Access Compliance Report Public Rights-of-Way (RR Crossings)

Intersection ID: 14235	Main Street: CAMDEN_RD	Location: N/A
ADA ID: 86B289BFCEB7	Overall Compliance: No	Severity Score: 0.0
Codes/Mitigation Info/Possible Solution		Field Measurements/Component Compliance

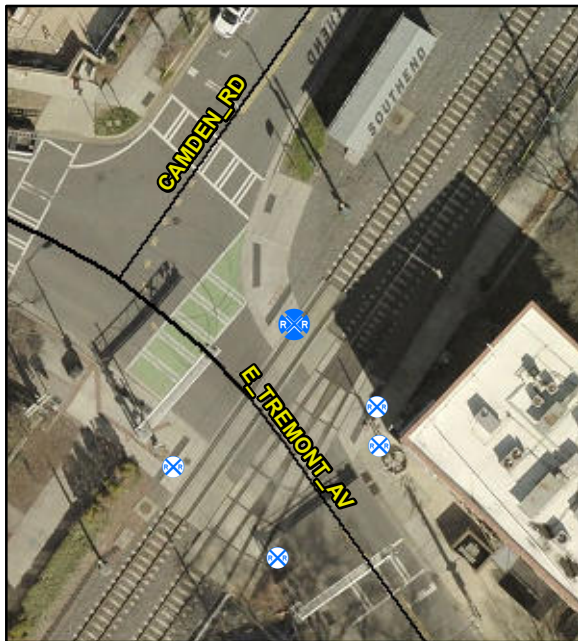
Compliance	Description	Data
Yes	DWS Provided?	Yes
Yes	DWS Contrast?	Yes
Yes	DWS Width (in)	Yes
Yes	DWS Length (in)	24.0
No	DWS Offset (in)	54.0
No	Pedestrian Gate?	No
N/A	DWS Outside Gate?	No
N/A	Rail Type?	LightRail
No	Flangeway Gap (in)	3.0
Yes	Sidewalk Width (in)	119.0

Remove & Replace Detectable Warning System. Provide Pedestrian Gate. Remove & Replace Walking Surface Adjacent to Rail.
